Work Order ID 129256

Item ID: D2731-7RG Accept *N900040100* Setup Start *NS1*
 Revision ID: Stop *NS2*
 Item Name: Mounting Lug
 Start Date: 1/30/15 Start Qty: 24.00 *24* Cust Item ID:
 Required Date: 2/20/15 Req'd Qty: 24.00 *24* Customer:
 Reference:

DRAWING NO. D2731	TITLE MOUNTING LUG	REV. C	DART AEROSPACE USA, INC ENGINEERING ORDER		D.E.O. NO. D2731-C-1	SHEET NO. SHEET 1 OF 1	SCALE NTS
DRAWN <i>q</i>	CHECKED <i>Sc</i>	MFG. APPR. <i>M</i>		APPROVED <i>AD</i>		DE APPR. <i>---</i>	
DATE 11.05.02	DATE 11.05.09	DATE 11.05.09		DATE 11.05.09		DATE 11.05.09

D2731-1RG MOUNTING LUG (SHOWN)
D2731-3RG/-5RG/-7RG MOUNTING LUGS (SIMILAR)

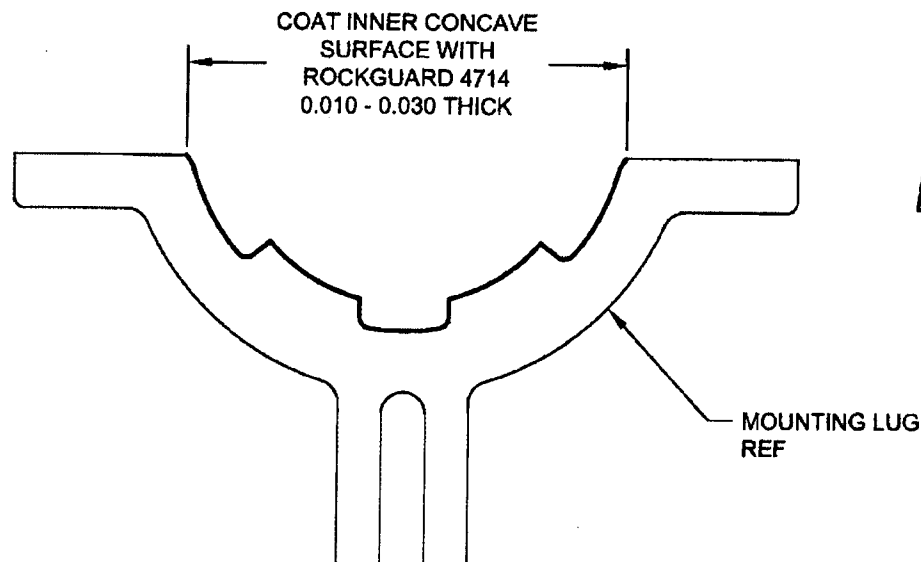
ADD D2731-xRG OPTION

D2731-xRG MOUNTING LUGS ARE INDENTICAL TO D2731-x MOUNTING LUGS, HOWEVER AFTER FINISH, COAT INNER CONCAVE SURFACE WITH "PLUS ONE ROCKGUARD 4714" AS SHOWN BELOW.
